UNITED STATES PATENT AND TRADEMARK OFFICE

APPLICATION NO.	FILING DATE	FIRST NAMED INVENTOR	ATTORNEY DOCKET NO.	CONFIRMATION NO.
10/824,658	04/15/2004	Joseph Hess	NOVAP0012	7721
24203	7590	03/15/2006	EXAMINER	
GRIFFIN & SZIPL, PC SUITE PH-1 2300 NINTH STREET, SOUTH ARLINGTON, VA 22204			MARTIN, LAURA E	
			ART UNIT	PAPER NUMBER
			2853

Office Action Summary	Application No. 10/824,658	Applicant(s) HESS ET AL.	
	Examiner Laura E. Martin	Art Unit 2853

DETAILED ACTION

Figure 3a

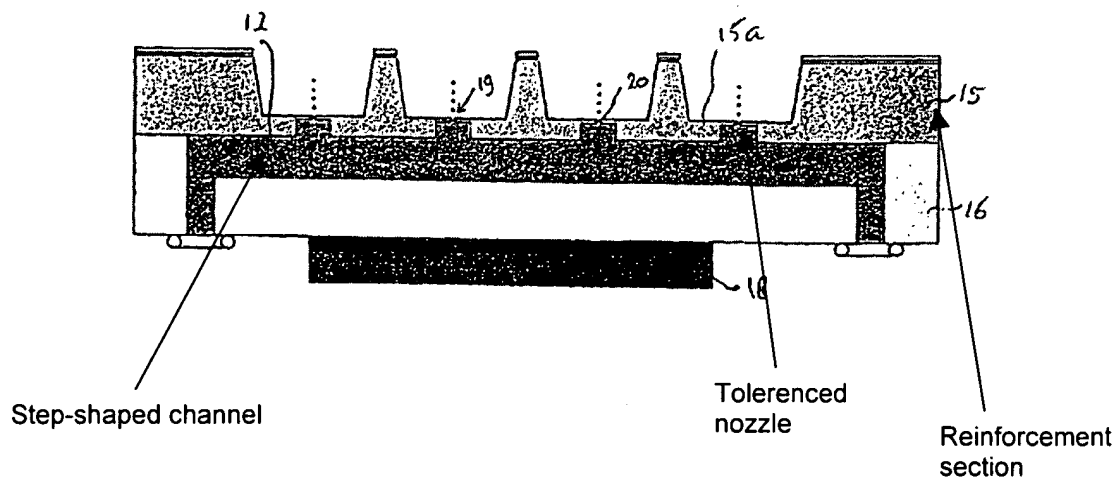
As per claim 1, Hess et al. teaches a nozzle body for a liquid droplet (figures 3a, 3b, and 3c) comprising: a first substrate in which a space is formed (figure 3a, element 16), a second substrate having at least one nozzle membrane section (figure 3a, element 15) and reinforcement section (figure 3a, element 15), wherein said first and second substrates are arranged such to enclose the space [0027], wherein each of said nozzle membrane sections comprises a high density array of outlet nozzles and output channels (figure 3a, element 20) that connect said enclosed space with each of said

outlet nozzles, said outlet nozzles and said output channels having a tightly toleranced, straight, non-tapered shape, wherein said second substrate has a top surface in which at least one cavity is formed (figure 3a, element 15a) so as to provide the nozzle membrane section corresponding to the bottom of said cavity with surrounding reinforcement sections, and a bottom surface adjacent to and enclosing said space thus forming a chamber for containing said liquid substance [0027-0029], wherein each said nozzle output channel is step shaped [0018] with a wider portion being adjacent said space and a thinner portion containing a protrusion section protruding beyond the top surface of said nozzle membrane section of said second substrate (figure 3a, element 15) such that the exterior side wall of the protrusion section of said output channel is a substantially straight angle with respect to the top surface of said nozzle membrane section of said second substrate (figure 3a, element 12). Examiner notes that the preamble does not hold weight to the claim rejection.

As per claim 9, Hess et al. teaches a liquid droplet spray device comprising a nozzle body (figure 3a) and a vibrating element disposed to vibrate liquid in said space so as to eject said liquid substance as a spray through the outlet nozzles (figure 3a, element 18; [0033]).
